BEACON PLANNING BOARD
Via Video-Conference
BEACON, NEW YORK 12508
Phone (845) 838-5002 Fax (845) 838-5026

Beacon Views - Conklin Street

Continue public hearing for SEQRA environmental review on applications for Subdivision and Site Plan Approval, "Beacon Views Townhouses" 40 units, Conklin Street, submitted by Beacon Views, LLC

RE: Beacon Views Site Plan and Conservation Subdivision
Conklin Street
Beacon, New York
Tax Parcel ID: 6055-03-331123

FIRE TRUCK MANEUVER 1
SCALE: 1" = 60'

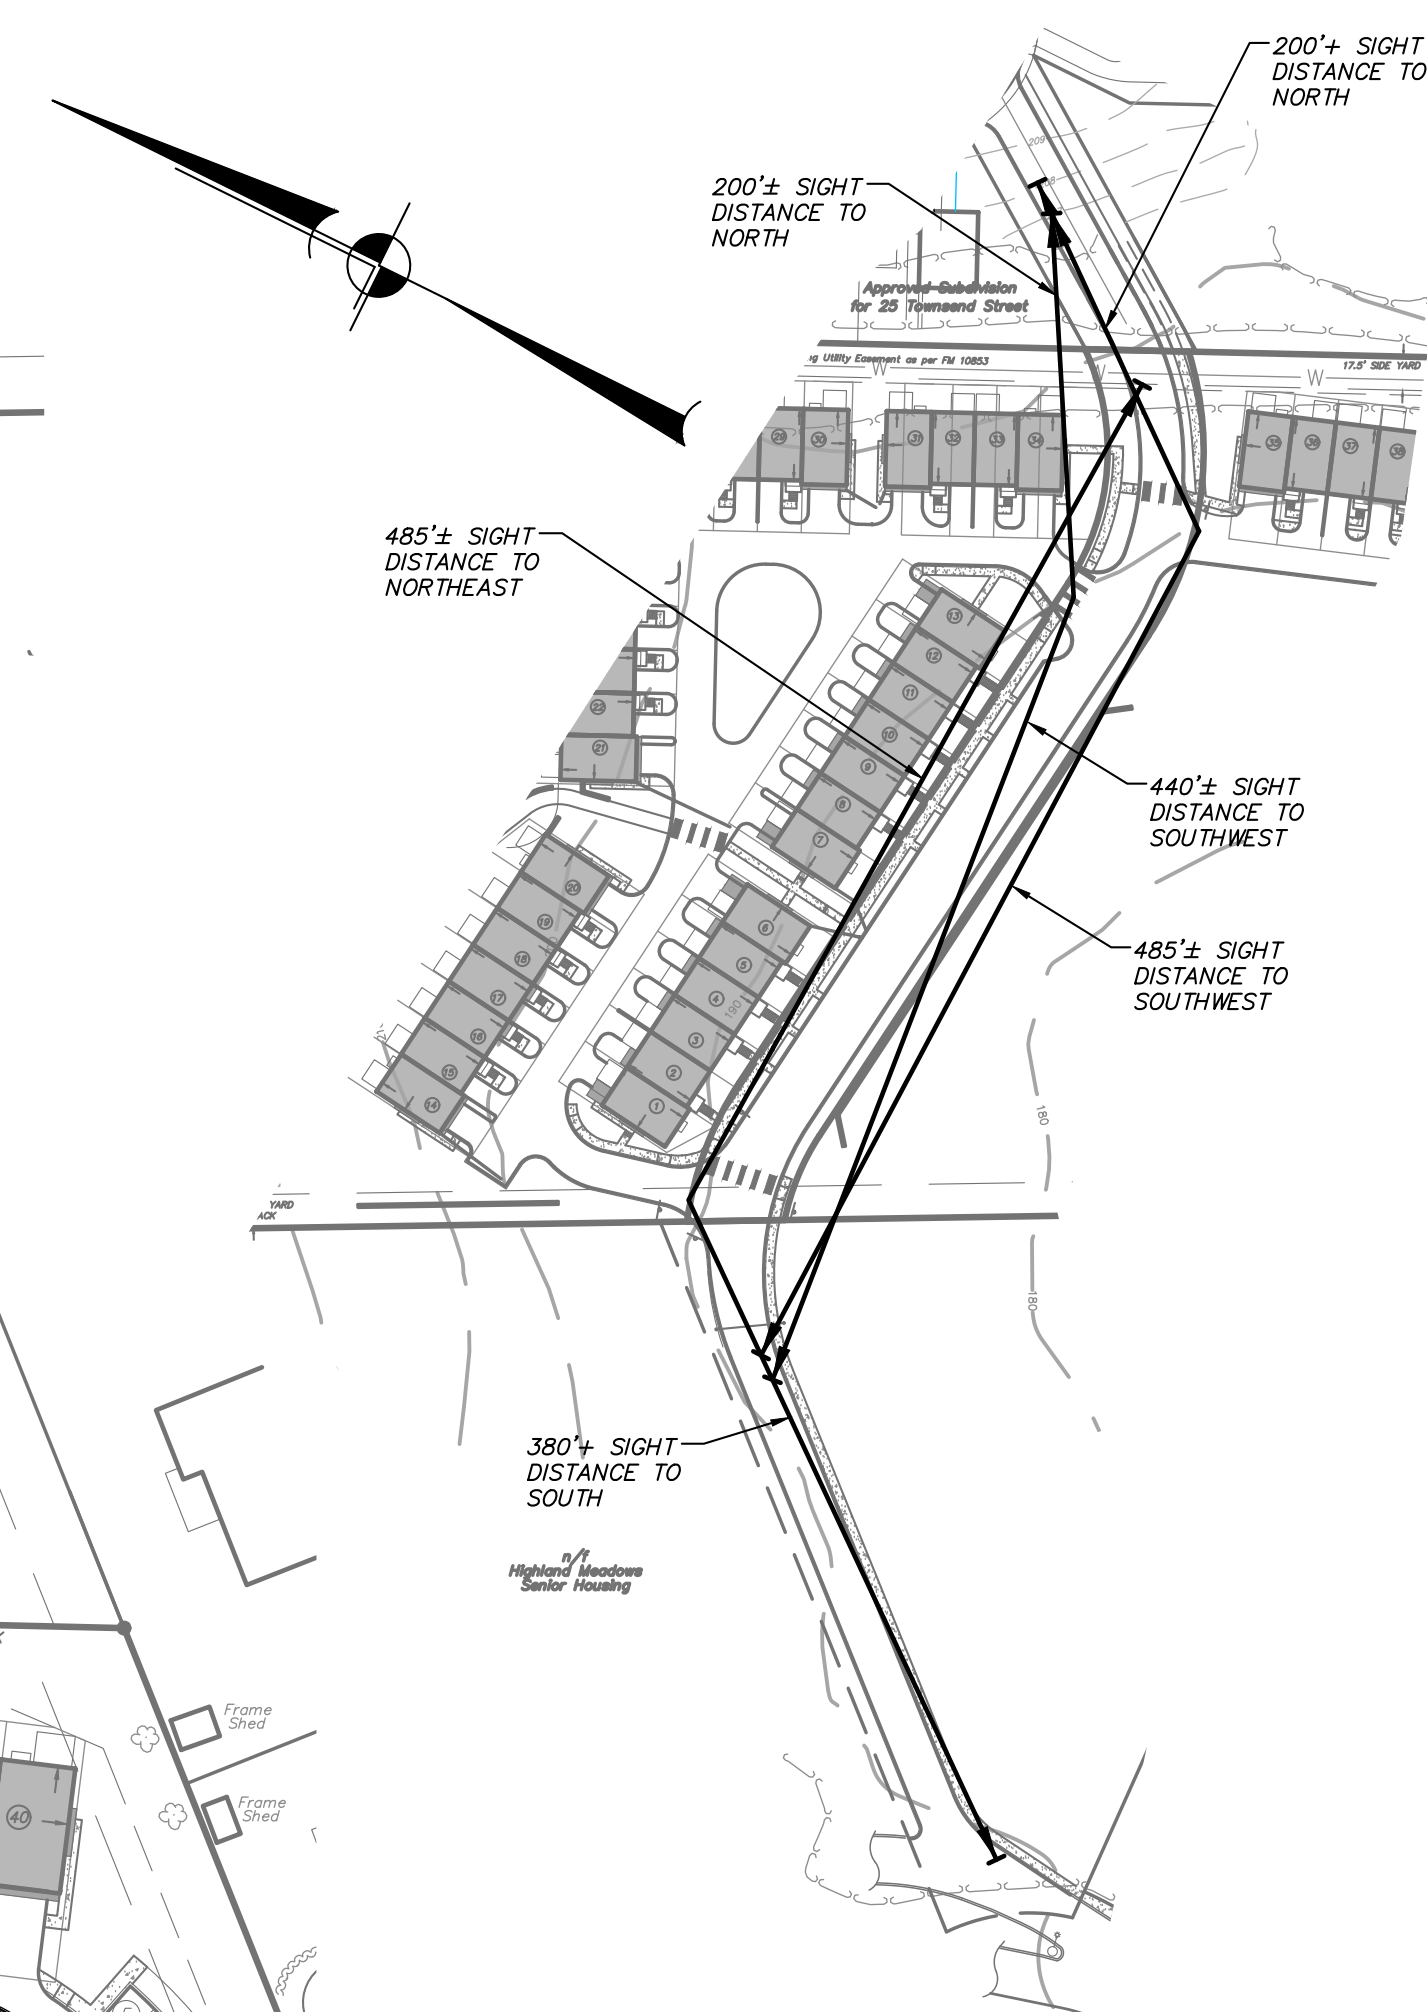
Vehicle Maneuvering Plan (Sheet 8 of 16):

1. The details for the vehicles used should be enlarged so that they are legible.
2. As noted in Comment No. 1 for Sheet 7 of 16 above, the cul-de-sac would need to be modified to provide for a through road in accordance with the City Code. The vehicle maneuvering plans should be revised to reflect this.

1. The additional vehicle maneuvers have been added to the plan as requested. It is the applicant's understanding that provisions for the realignment of the 25 Townsend Street road, including the elimination of the circle, in the event that it was to become a through road, were included and approved with that application.

PROPOSED WATER MAIN LOOP PROFILE

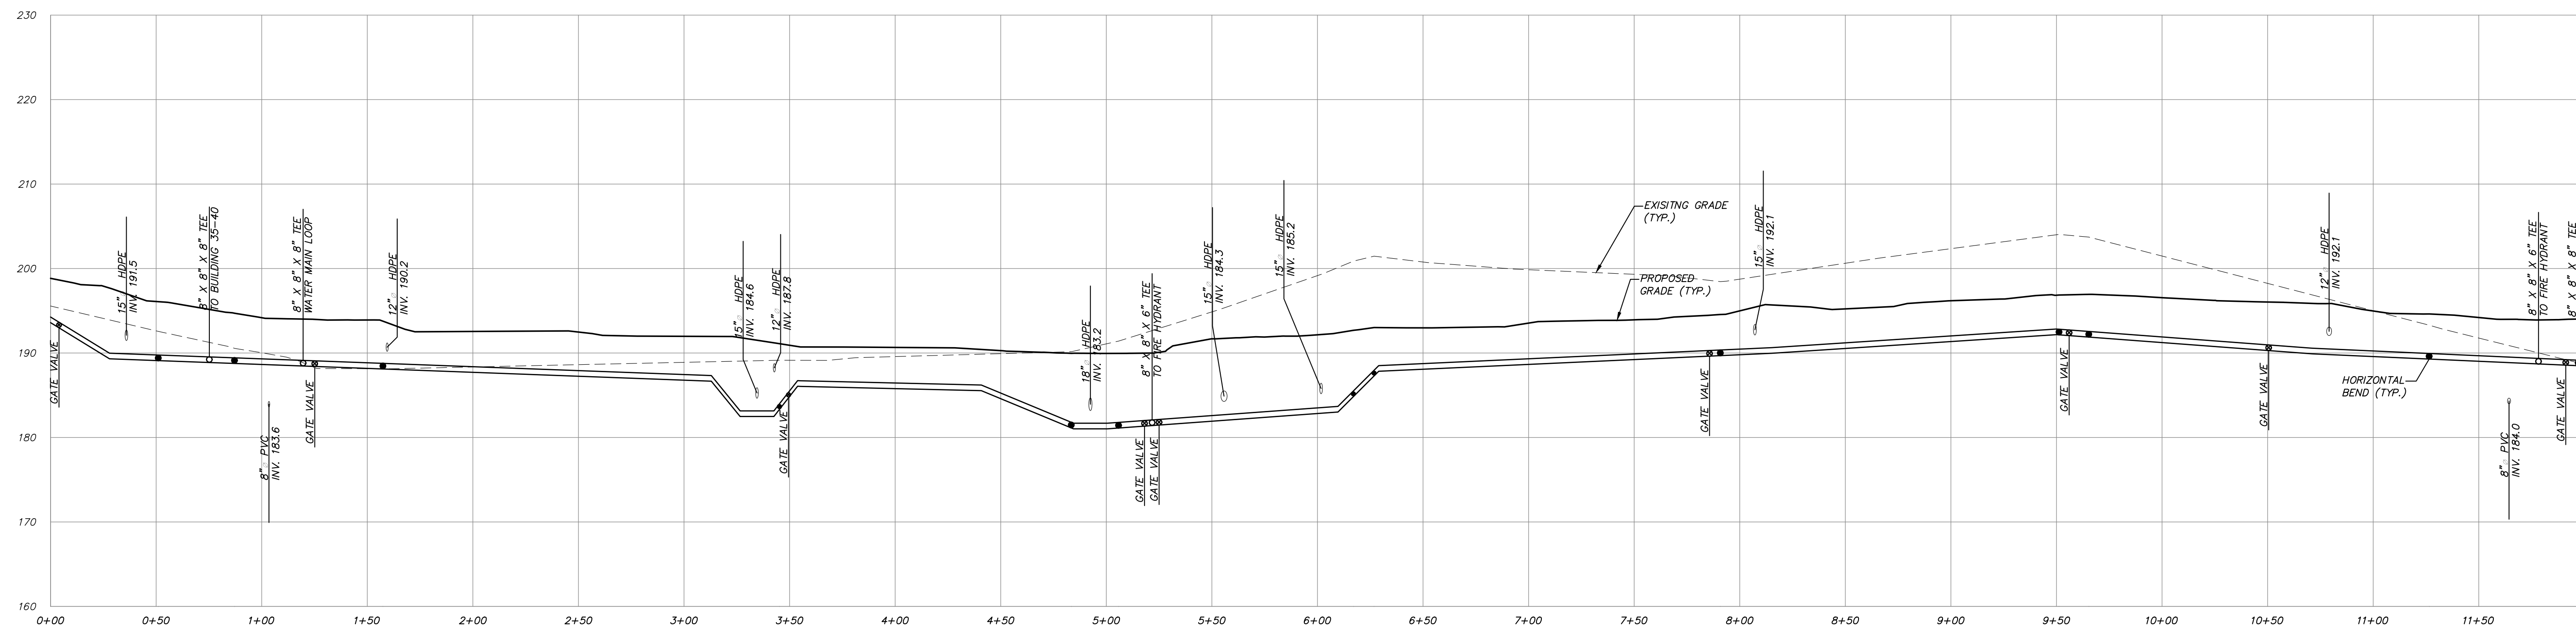
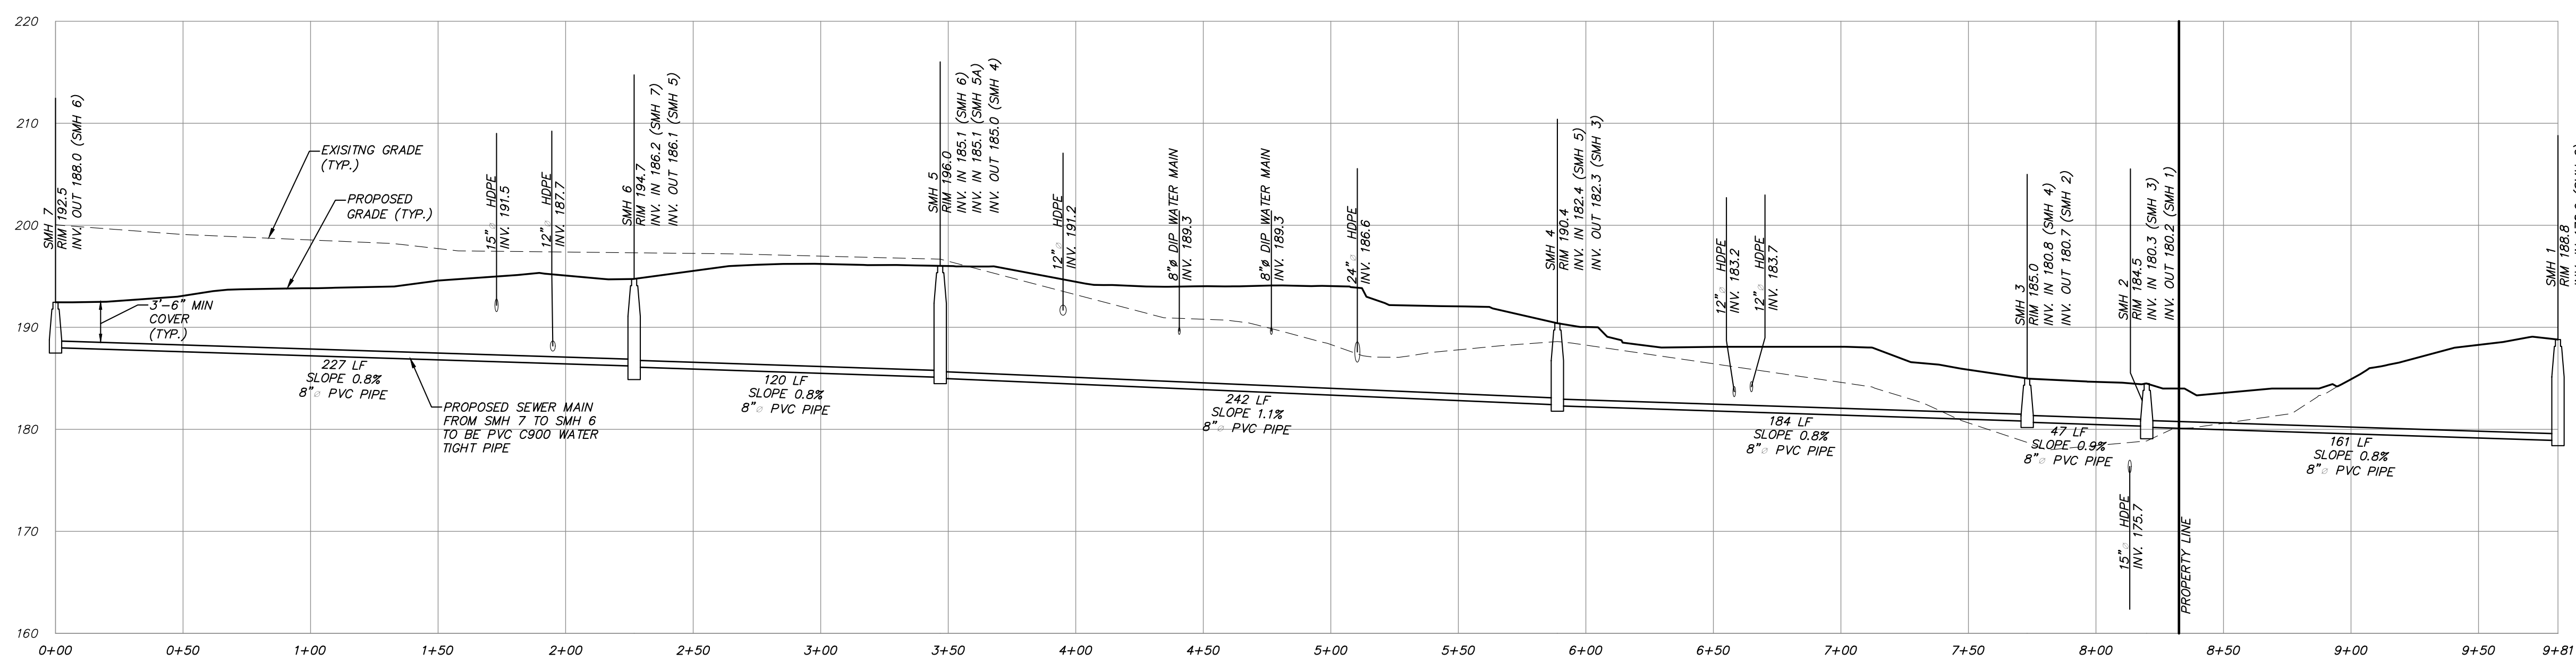
Water & Sewer Profiles (Sheet 11 of 16):

1. The proposed vertical and horizontal bends have been labeled as requested.
2. The portion of the water main in question has been eliminated from the proposed system.
3. The connection through 25 Townsend is no longer proposed, therefore profiles in this area are no longer required.

JOB #: 2020-005
DATE: 4/28/2020
SCALE: 1" = 20'
TITLE: GR-1
SHEET: 6 OF 10

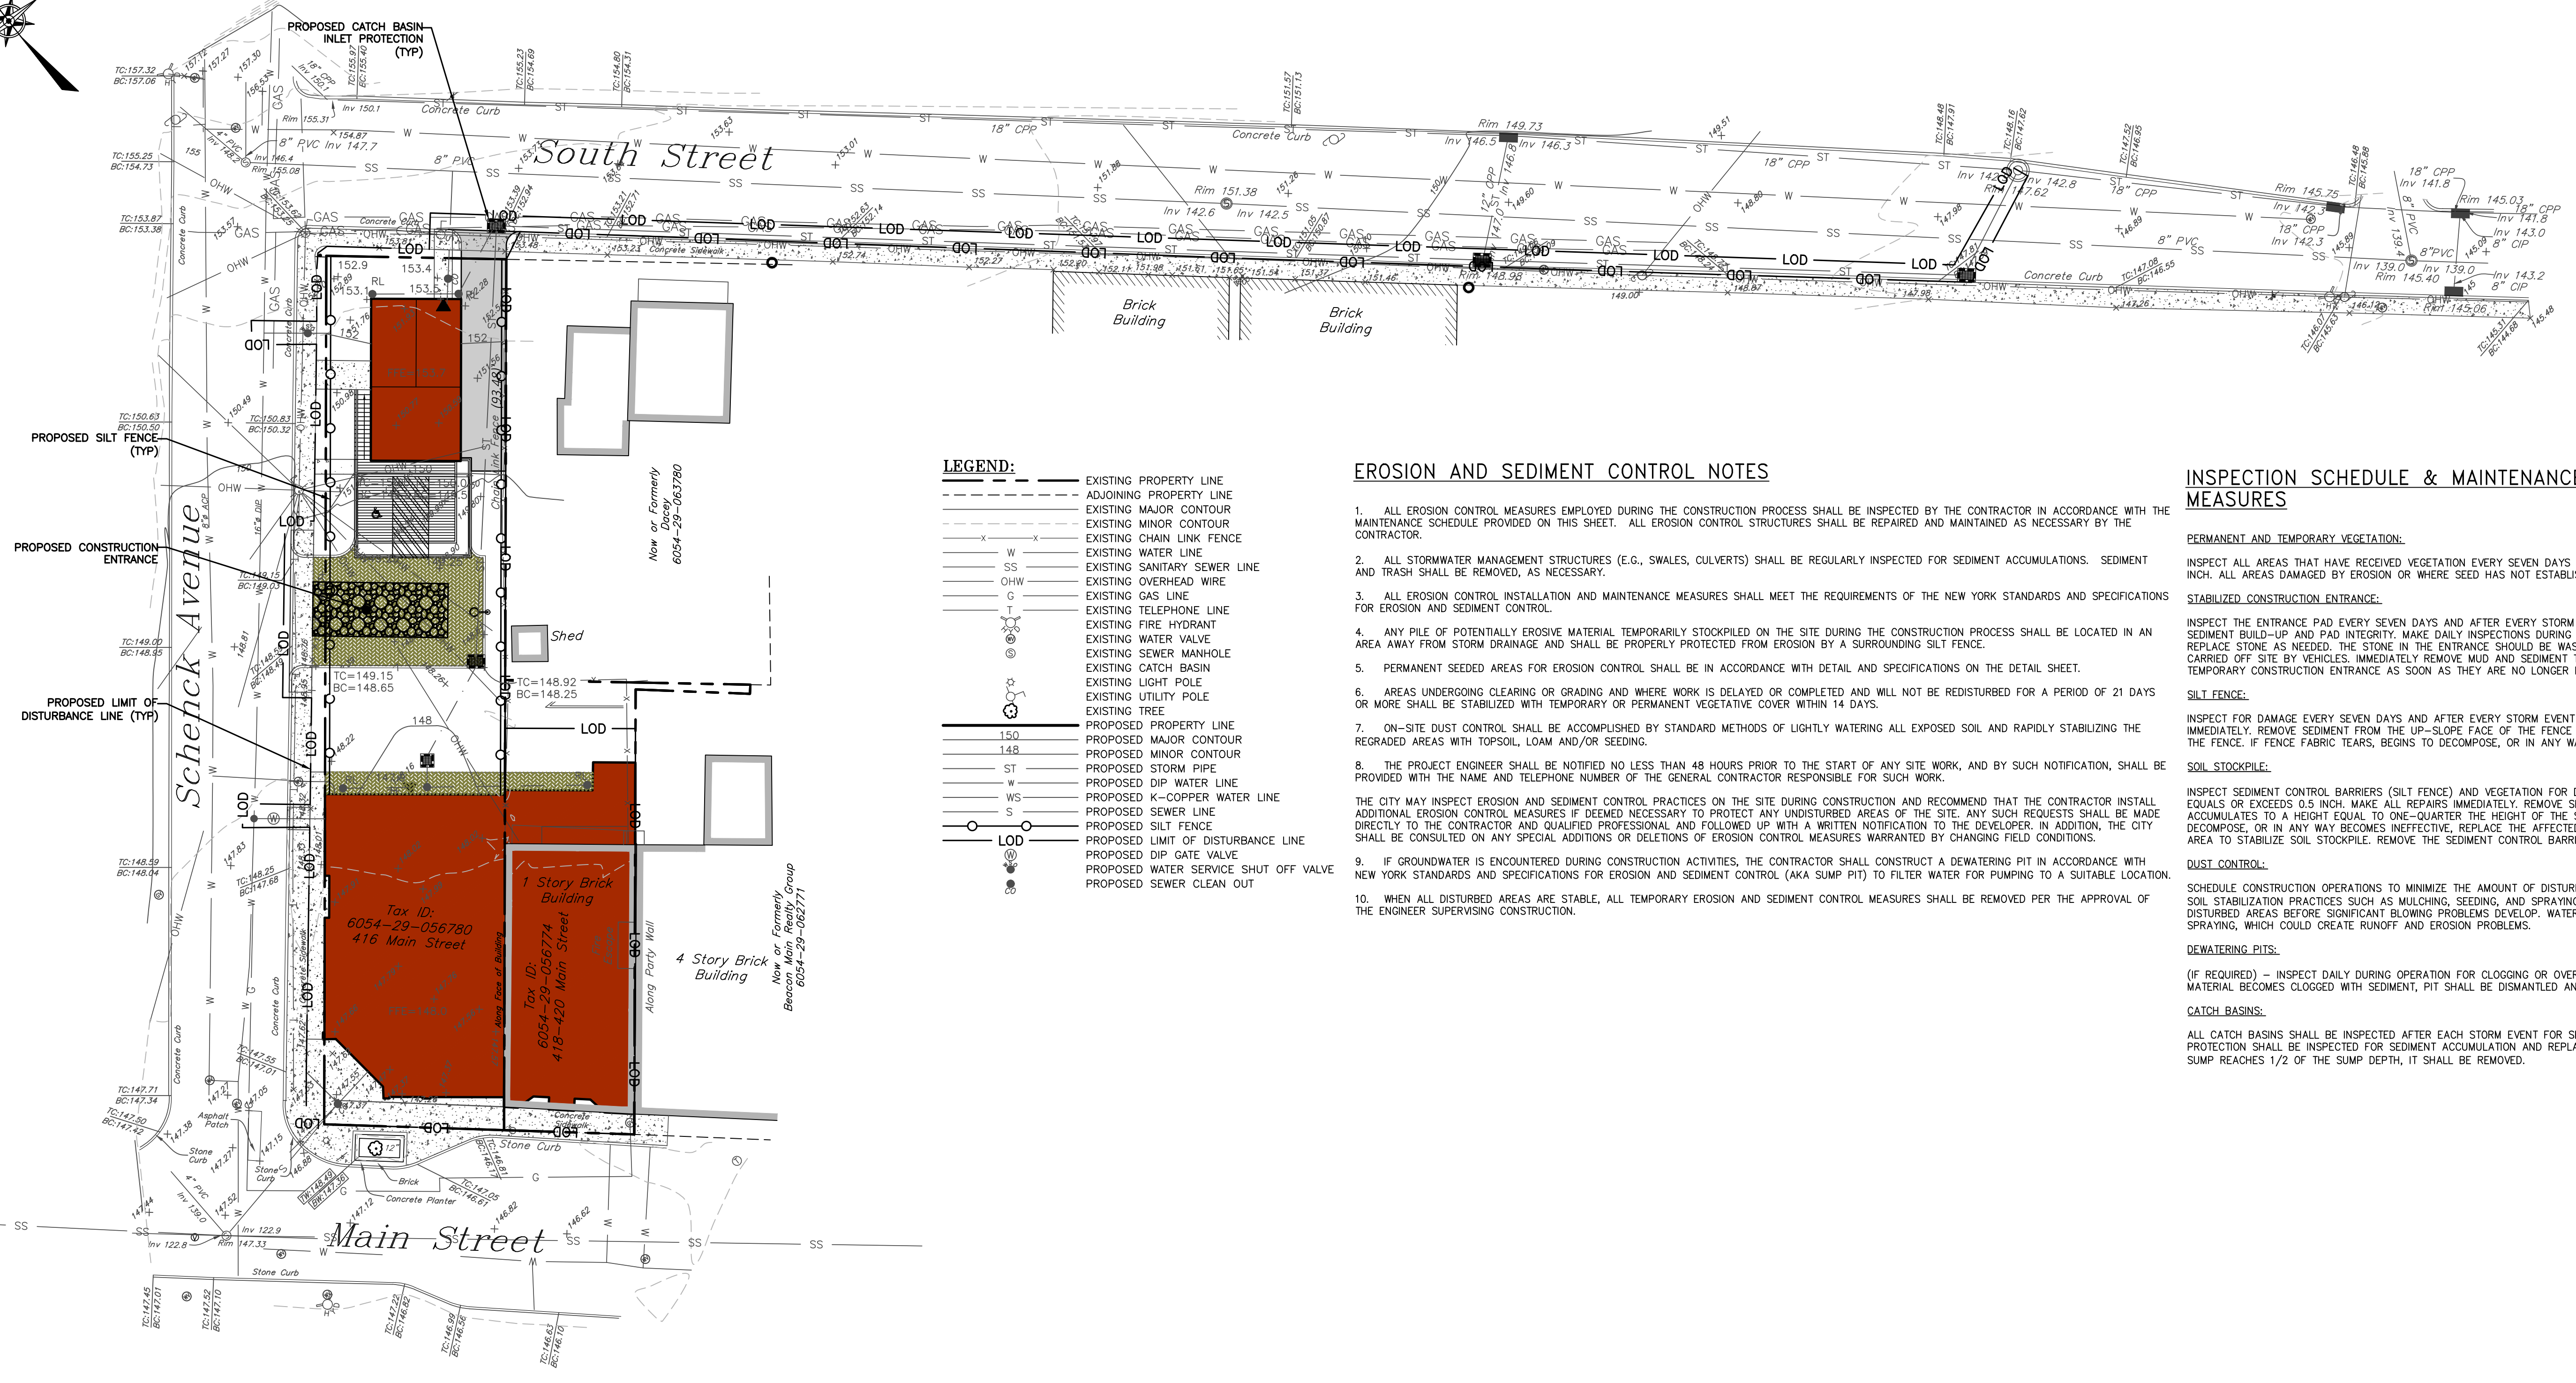
Grading Plan (Sheet 6 of 10):

1. We would recommend that the sheet titled be revised to "Grading & Utility Plan", as this plans also reflects proposed utilities and for consistency with what is noted within the Index of Drawings on Sheet 1 of 10.
